ATTACHMENT A

Revise the Technical Specification pages as follows:

DESIGN FEATURES

## ATTACHMENT B

FIGURE 5.1-1

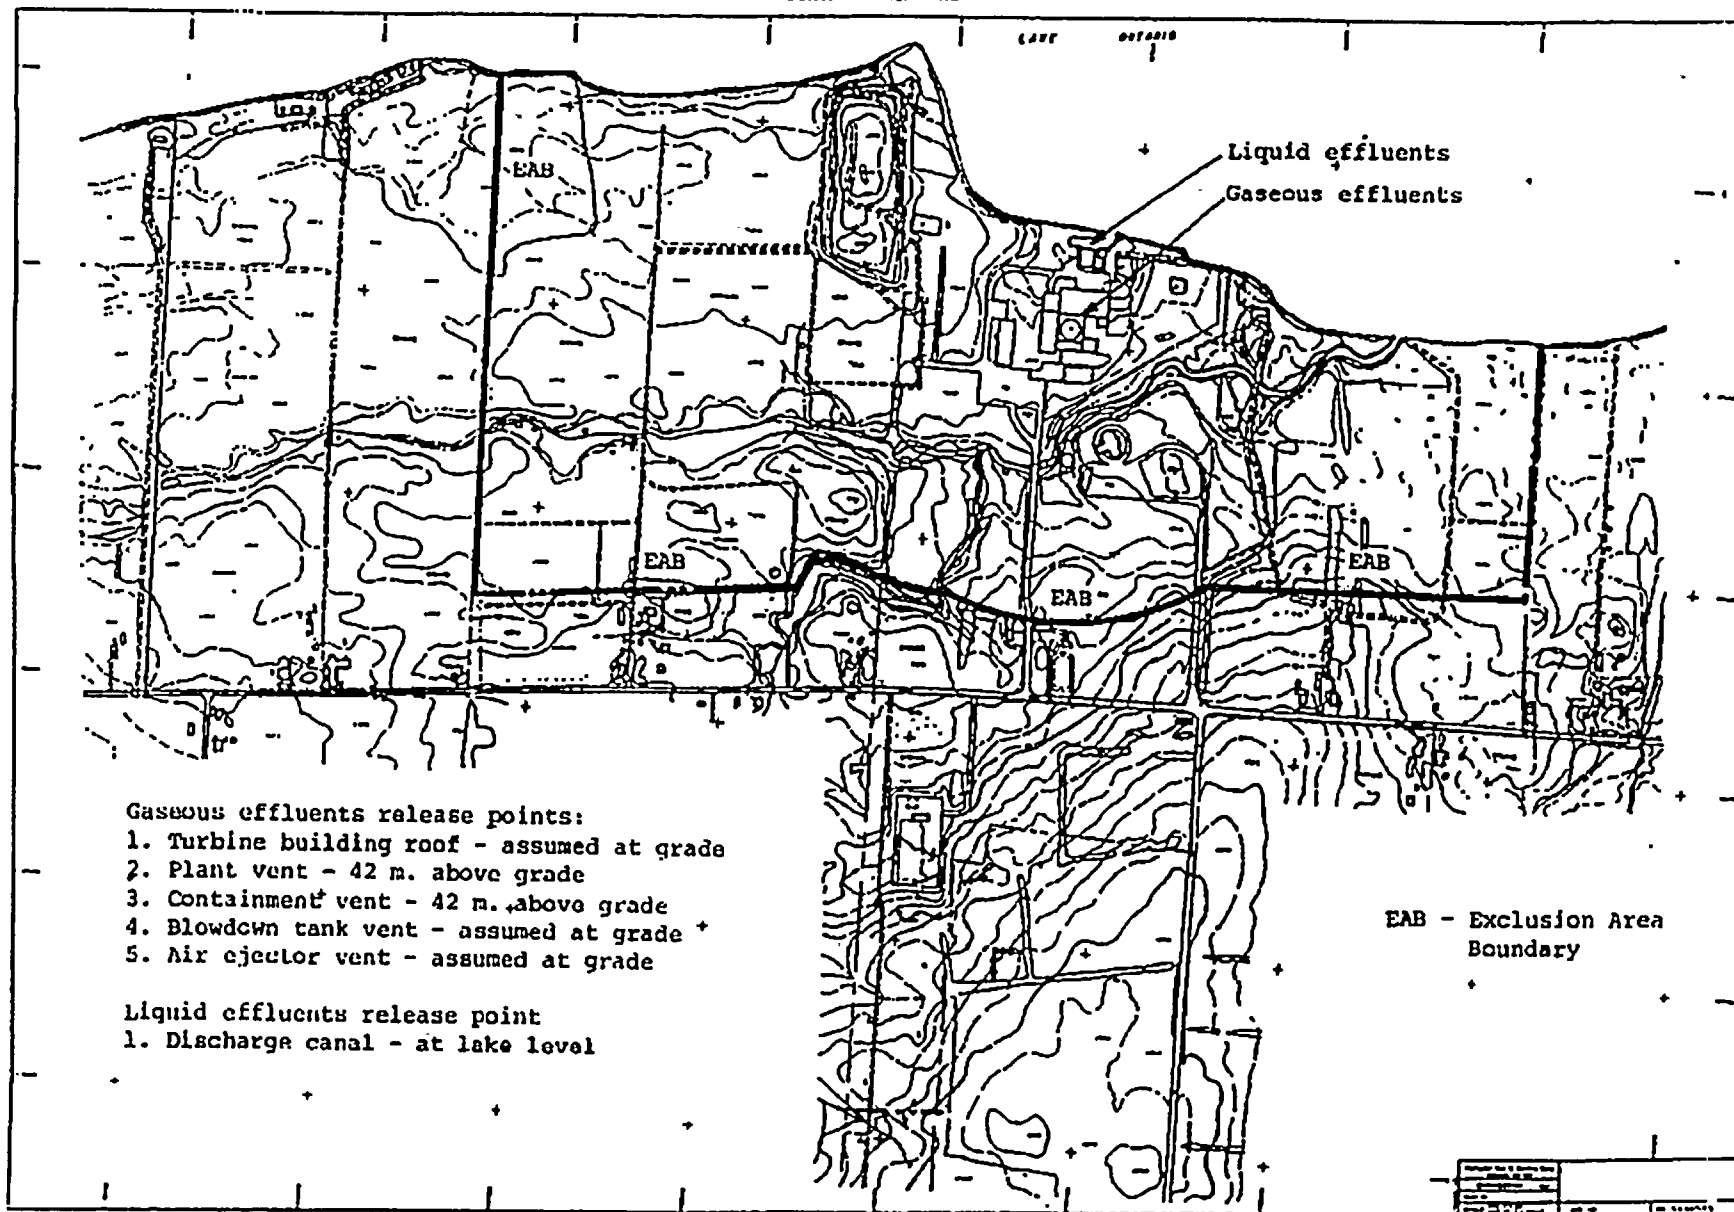
The proposed Amendment redefines Ginna's site area boundary (the RG&E property line) in terms of text rather than a depiction, as shown on Technical Specification Figure 5.1-1. The proposed change will define the Site Area Boundary line as:

The proposed change to describe the site area boundary in terms of text will compensate for the removal of Ginna's Site Area Boundary from existing Technical Specification Figure 5.1-1. This proposed change does not alter the substance of the guidance provided in NUREG-0133, but rather only provide flexibility.

For the purposes of implementing Ginna Radiological Technical Specifications, and for evaluating radiological releases to the Unrestricted Area, the Unrestricted Area Boundary is assumed to coincide with the Exclusion Area Boundary. The site map shown in Figure 5.1-1 depicts the Ginna Exclusion Area Boundary (also called Unrestricted Area Boundary) location.

The site boundary shall be that line beyond which the land is neither owned, nor released, nor otherwise controlled by Rochester Gas & Electric Corporation.

"The site boundary shall be that line beyond which the land is neither owned, nor leased, nor otherwise controlled by Rochester Gas and Electric Corporation."
